**PLANNING COMMISSION MEETING  
AGENDA  
CITY OF WHITE BEAR LAKE, MINNESOTA**

**TO:** The Planning Commission

**RESOLUTION APPROVING A  
PLANNED UNIT DEVELOPMENT AND  
PRELIMINARY PLAT OF  
ROSE'S PARK VIEW ADDITION AT  
1788 COUNTY HIGHWAY 96 EAST  
WITHIN THE CITY OF WHITE BEAR LAKE, MINNESOTA**

# ROSES PARK VIEW ADDITION PRELIMINARY PLAT

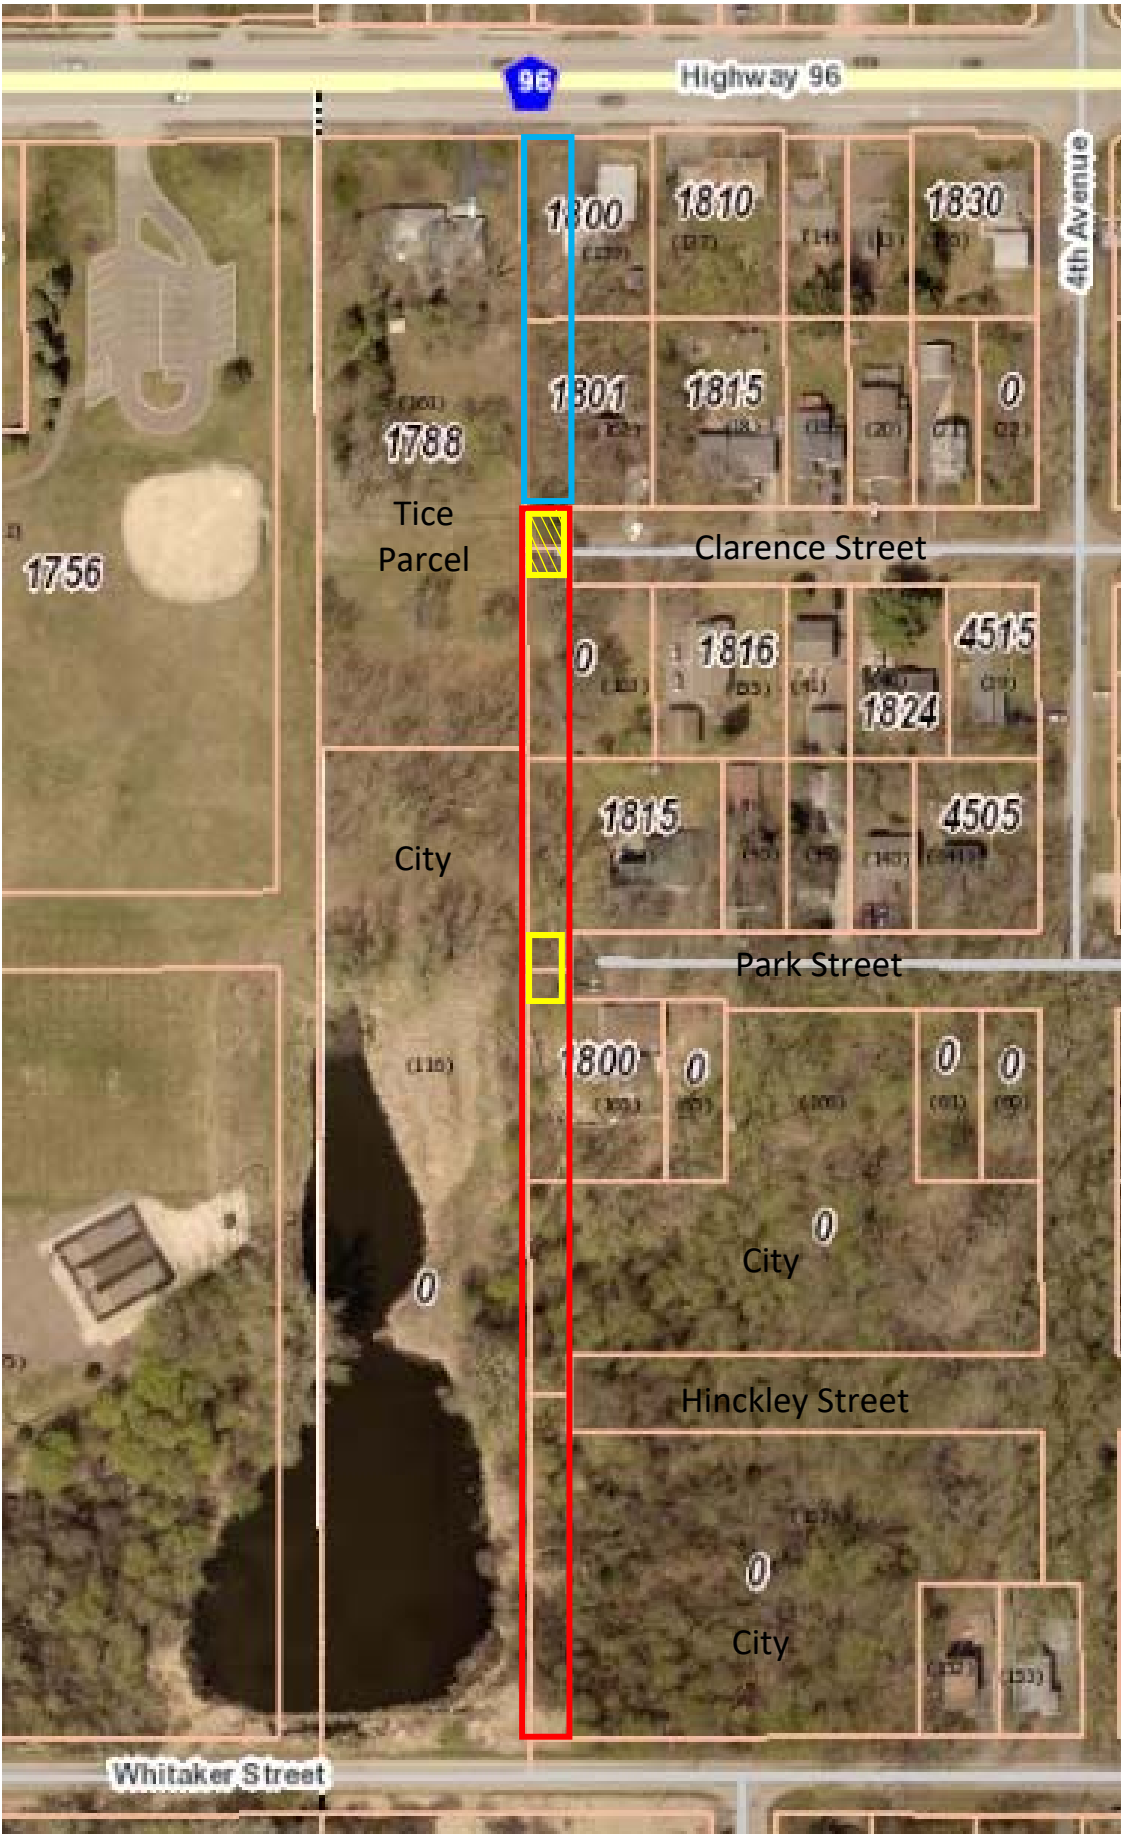
City staff has reviewed the matter and agrees that not all of the erroneous Vacation “B” needs to be rescinded. Only the two 60 foot wide areas over the west end of Clarence Street and Park

Street are needed for access and utility purposes. (See the yellow areas in the graphic depiction.) The Hinckley Street street-end is not needed because it is completely surrounded by City-owned property.

Staff reached out to Ramsey County who expressed doubt about the legal viability of leaving a mistake in place. It appears that the best path forward would be for the Council to re-affirm the denial of Vacation “B”, but simultaneously approve a new two-part vacation of 5<sup>th</sup> Avenue: from the south of Clarence Street to the north of Park Street, and from the south of Park Street to the north of Whitaker Street. This would leave the directly adjacent neighbors the land that they have believed was theirs for the past few decades and would also provide the public road access to the Tice parcel that is desired for logical site layout and development.
